Response to Observations

In respect of a Part X & XAB
(S175 and S177AE)
Planning Application for

Phase 1 Corrib Causeway
Development at

Dyke Road, Terryland,
Galway

Figure 1 - Dyke Road Carpark Occupancy Rates - Weekdays (Source: PUNCH TTA)

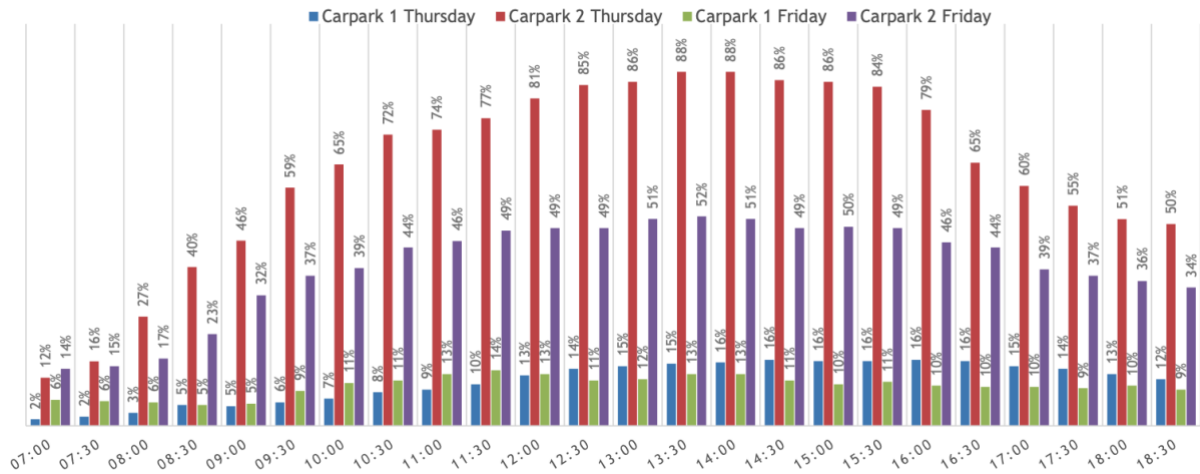
- The substantial reduction in existing car parking provision.
- Anticipated overflow parking into adjacent retail park areas.
- The absence of alternative parking or transport mitigation strategies.
- Increased parking pressures during peak drop-off and pick-up times associated with the proposed childcare facility.
- Reference to the Headford Road multi-storey car park proposal, questioning its feasibility.
- Lack of clarity regarding car parking allocation within the proposed development.
- Overall insufficiency of car parking spaces relative to the scale of the residential development, with particular reference to the proposed ratio of 0.15 spaces per unit.

The Traffic and Transportation Assessment (TTA) prepared by PUNCH Consulting Engineers forming part of the application documentation had carried out an assessment of the impact of the removal of car parking space (Section 3.4 of the TTA, refers). A car park usage survey was carried out over three consecutive days from Thursday 16th November 2023 to Saturday 18th November 2023 between the

hours of 07:00 – 19:00. This gathered representation of both weekday and weekend usage data. Throughout the entire survey period, Carpark 2 (of which 165 no. spaces are being retained) had a higher occupancy than Carpark 1 (subject site of proposed development), with users choosing to use Carpark 1 only when Carpark 2 had started to fill up. The overall carpark tended to fill up from the southern end (city-site) first with user preference to park closer to the Headford Road.

Figure 6 - Permitted BusConnects Cross City Link

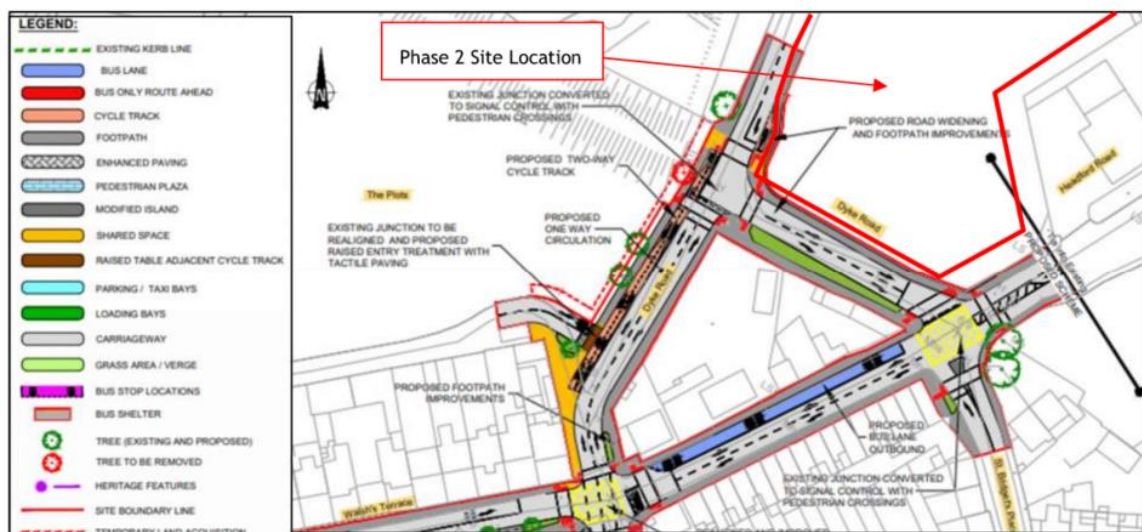
There are currently no pedestrian crossing points on the Dyke Road after the Dyke Road/Headford Road signal-controlled junction.

As referenced in Section 3.5.4 of the TTA, planning permission was granted for the Galway BusConnects scheme Cross-City Link (University Road to Dublin Road) in October 2024 (Reg. Ref. ABP 314597). This section of the BusConnects scheme includes a new signal-controlled junction on the Dyke Road with new pedestrian crossings on each arm and significantly improved pedestrian routes in this section of Dyke Road, as shown in the figure below:

The proposed toucan crossing of the Dyke Road that is included in this proposed development application is approximately 220m from this permitted new pedestrian crossing and approximately 300m from the existing pedestrian crossing of the Dyke Road/Headford Road junction. The proposed location of the new crossing point is positioned at the northern end of the proposed development providing good connections for the development entrance and the Black Box Theatre.
